Tech Notes

100-187 SCR RECEIVER RELAY MODIFICATION

100-187 SCR Receiver, (reverse side).

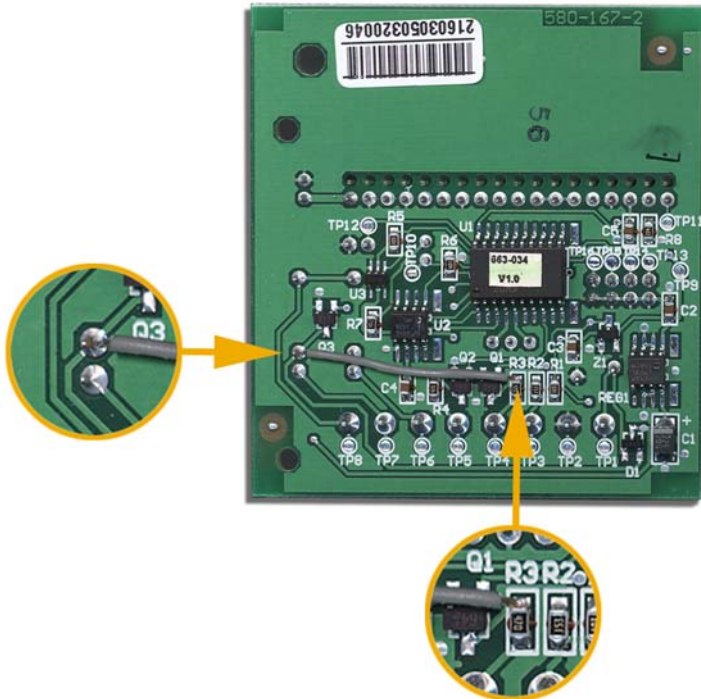
MODIFICATION TO ALLOW THE *PANIC BUTTON* ON A NESS RADIO KEY TO DRIVE THE RELAY OUTPUT.

Use a fine tipped soldering iron to solder a wire link between the solder pad adjacent to the collector of Q3 and one side of R3, (as shown).
